Subject: TP3K XL² DVD Boot Order and P15 BIOS

BIOS P15 has been validated and released for the TeamPoS 3000 XL² and XT² terminals. The BIOS is available on the FTP web site:

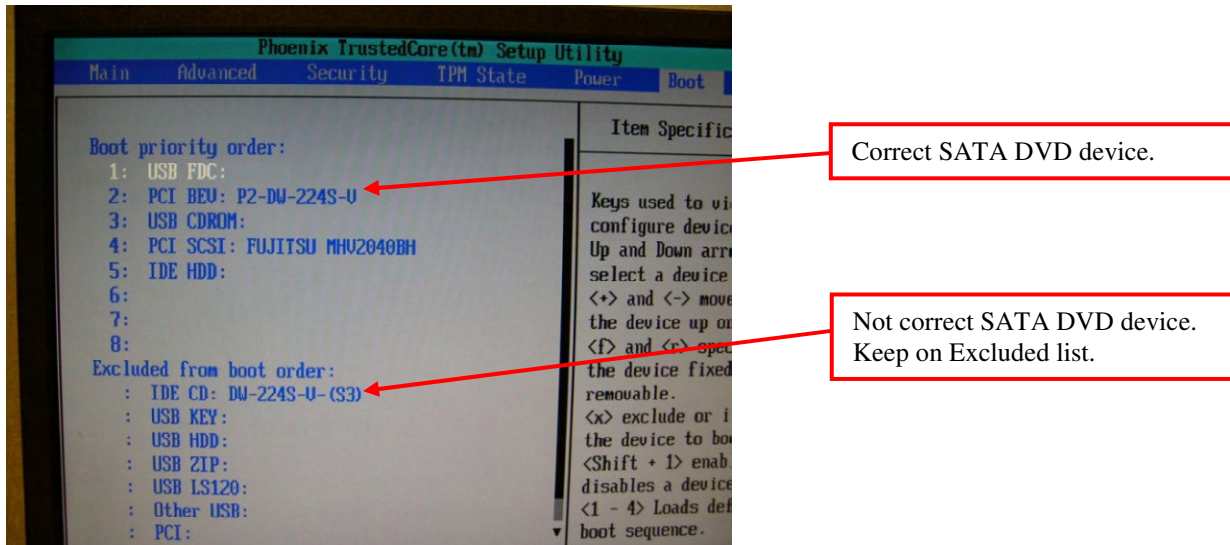
The new P15 BIOS has 2 changes from the currently P11 BIOS (the interim versions were never released).

- Fixed system stop at post when SATA DVD/CD-ROM is connected.
- Updated microcode for new SLA J9 Step Code. – Reference PSB-12-006 for details.
